Technical Specification Group Services and System Aspects TSGS#27(05)0113
Meeting #27, 14 - 17 March 2005, Tokyo, Japan

Source: TSG SA WG2
Title: CR(s) to 23.903
Agenda item: 7.2.3
Document for: APPROVAL

| ⌘ 23.903 CR 001 ⌘ rev 0 ⌘ | Current version: 6.0.0 ⌘ |

| Title: | ⌘ Incorrect sequence of events in 4.3.1.1 | | |

Figure 2: Radio degradation at UE 2 leading to fallback to voice

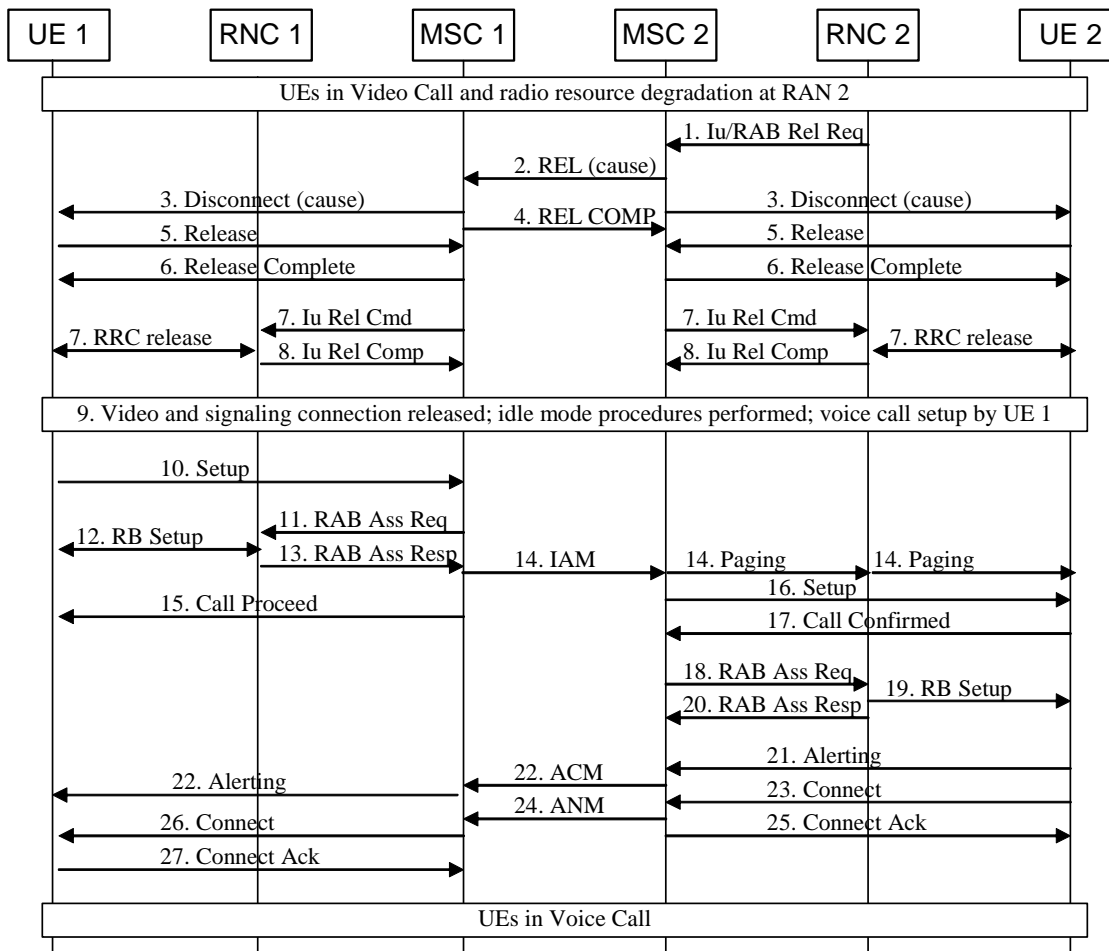
| Reason for change: | ⌘ In the “fallback from video to voice” message sequence, there is text about the UE prompting the user to confirm the redial attempt. However this is incorrectly placed in step 3 instead of step 10. |
| Summary of change: | ⌘ Text is removed from step 3 and related text is added to step 10. |

2. MSC 2 sends a REL message with the release cause. This cause value in the REL message might be changed by transit networks prior to arrival at MSC 1.
3. The MSCs send Disconnect messages to the UEs. ~~UE 1 should first confirm the Redial attempt (not shown here) with its user.~~

10. [UE 1 prompts its user to attempt a Redial](#). When UE 1 gets the Redial confirmation from its user it sends a SETUP message (containing the Redial indication) to MSC 1 to setup a Voice call.
